5. Canyon View 2022; KPB File 2022-034

ITEM 5 - CANYON VIEW 2022

KPB File No.	2022-034
Plat Committee Meeting:	August 8, 2022
Applicant / Owner:	Evdokia Reutov & Petro Basargin both of Homer, Alaska
Surveyor:	Gary Nelson / Ability Surveys
General Location:	East End Road and Canyon View Road, Fox River / Kachemak APC

STAFF REPORT

CANYON VIEW 2022

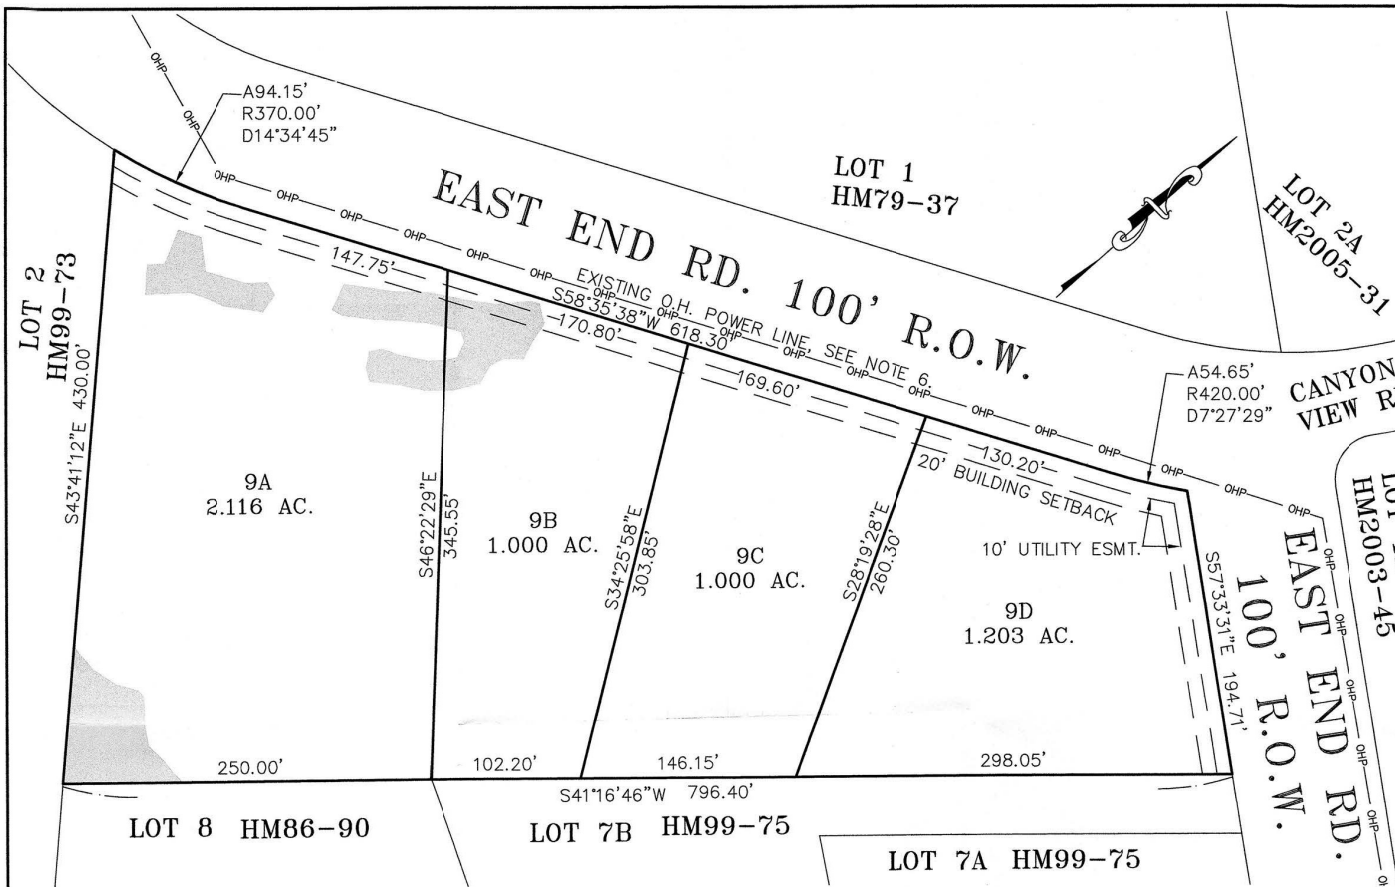
Staff recommendation: *Total acreage of lots is different than title block, verify for final.*
- D. A vicinity map, drawn to scale showing location of proposed subdivision, north arrow if different from plat orientation, township and range, section lines, roads, political boundaries, and prominent natural and manmade features, such as shorelines or streams;

Staff recommendation: *There are some overstrikes on section labels and the road label. Adjust or use symbology to make all labels easy to read.*
- G. The status of adjacent lands within 100 feet of the proposed subdivision boundary or the land status across from any dedicated rights-of-way that adjoin the propose subdivision boundary, including names of subdivisions, lot lines, block numbers, lot numbers, rights-of-way; or an indication that the adjacent land is not subdivided;

Staff recommendation: *Add a right-of-way width label to Canyon View Road.*
- M. Approximate locations of slopes over 20 percent in grade and if contours are shown, the areas of the contours that exceed 20 percent grade shall be clearly labeled as such;

Staff recommendation: *Check indicated locations in front of lots 9A and 9B for correctness.*
- N. Apparent encroachments, with a statement indicating how the encroachments will be resolved prior to final plat approval;

Staff recommendation: *Check the location of the structure to line between Lots 9C and 9D to be sure it does not encroach. Encroachments are not accepted or approved. If the structure is to be on Lot 9C, show how it will be accessed. If accessed through Lot 9D, an access easement should be created.*

20.30.220. Lots-Side line requirements. Where reasonable, side lines of lots shall be at right angles to straight portions of the right-of-way or radial to curved portions of the right-of-way.
Staff recommendation: *Lines are not at right angles, but reasoning is seen.*

Staff recommendation: *comply with 20.60.110. Check the total line distance versus the individual lines on the West side.*

Staff recommendation: *Place the following notes on the plat.*

- *"No access to state maintained rights-of-way permitted unless approved by the State of Alaska Department of Transportation."*
- *The borough will not enforce private covenants, easements, or deed restrictions per KPB 20.60.170.*
- *Provide the correct wastewater disposal note based on the soils analysis report.*
